Centre for Environmental Rights

SUBMISSIONS ON ESKOM'S APPLICATION FOR SUSPENSION, ALTERNATIVE LIMITS AND/OR POSTPONEMENT OF COMPLIANCE WITH THE MINIMUM EMISSION STANDARDS FOR 10 OF ITS COAL-FIRED POWER STATIONS

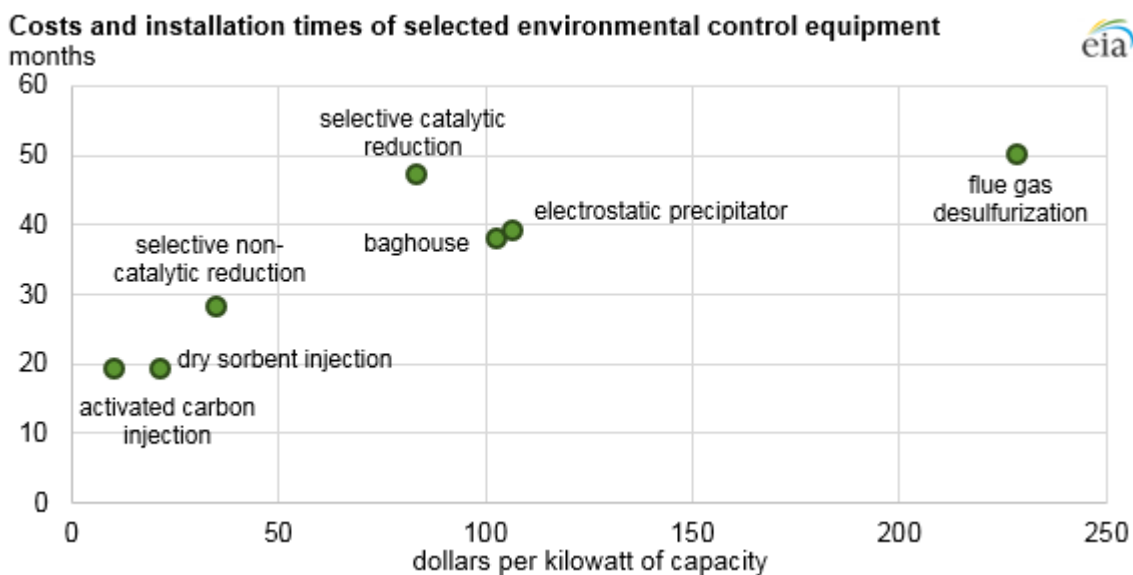
74. In relation to Eskom's "*updated planned retrofit schedule*", we take issue with the statement that Eskom is "*committed to implementing the technology elements of its emission reduction plan*" and "*to ensure the continued legal operation of its plant[s]*". A condition of the first set of multiple postponements granted to Eskom, which, we submit, still did not justify the decision to approve the majority of the applications, was to comply with the emission reduction plan submitted to DEA. It is clear from Figure 1 in the Summary Motivation Report that it has been unable to do so.

97. We submit that although the “decommissioning dates” in Figure 1 in the Summary Motivation Report may (or may not) suffice for the purposes of the draft 2018 Integrated Resource Plan for Electricity, it is not a “detailed” or “clear” decommissioning schedule, as is legally required by the List of Activities and the 2017 Framework for applications for suspension. It is our firm stance that it is not permissible for the NAQO and licensing authorities to consider the suspension applications, based on the non-compliance with NAAQS and the fatal health impacts associated with Eskom’s coal-fired power stations. In the event that the NAQO elects to disregard the reasons for our objections, which we would argue would be irrational and unlawful in itself, and considers Eskom’s decommissioning dates, we submit that it is not a “detailed” or a “clear” decommissioning schedule for the following reasons:

97.1 The decommissioning information in Figure 1 is limited to approximate decommissioning dates, as opposed to a precise schedule presenting the key actions and timelines to enable the decommissioning of at least the 5 stations included in the suspension application.

97.2 As a minimum, Figure 1 and/or the explanatory text around it should specify the commencement date/planned commencement date of the necessary regulatory requirements to authorise the decommissioning process, including, *inter alia*:

97.3 The processes identified above require both lead-time and budget – Eskom’s decommissioning table addresses neither. In fact, in its 2017/8 Integrated Report, Eskom’s Corporate Plan “*does not include any specific costs or impacts of the decommissioning of power stations, although it does include cost reductions associated with the extended cold reserve strategy*”.¹¹⁰ Hendrina power station was supposed to commence with decommissioning from 2018 and Camden power station from the beginning of 2020, yet there appears to be no decommissioning schedule, plan, or financial resources allocated to these processes.

97.4 In relation to Camden power station, we further note that “*Possible delay of decommissioning” – there is no explanation, reasonable or otherwise, for the cause of this possible delay or a revised decommissioning period.

99. We therefore submit that the decommissioning table in Figure 1 does not satisfy the List of Activities and 2017 Framework requirements for a detailed and clear decommissioning schedule. Notwithstanding the NAAQS non-compliance requirement and the health impacts attributed to Eskom’s power stations, the suspension applications should be dismissed on this basis. Alternatively, we submit that Eskom should provide a detailed and clear decommissioning schedule that at least reflects the plans and process referred to above, on the following conditions:

- 99.1 the detailed decommissioning schedule, as updated, is available for public comment as part of this application process and every 6 months through to 2030 for the purposes of progress monitoring;
- 99.2 the 5 “most costly and oldest plants” – Kriel, Arnot, Hendrina, Camden and Komati (and Grootvlei which is excluded from this application) – should immediately commence with decommissioning arrangements, required by law or otherwise, and provide evidence of these initiatives to the NAQO, competent licensing authorities and all I&APs; and
- 99.3 The social impact of decommissioning is clearly outlined in an inclusive and transparent social and labour closure plan developed for the decommissioning process.
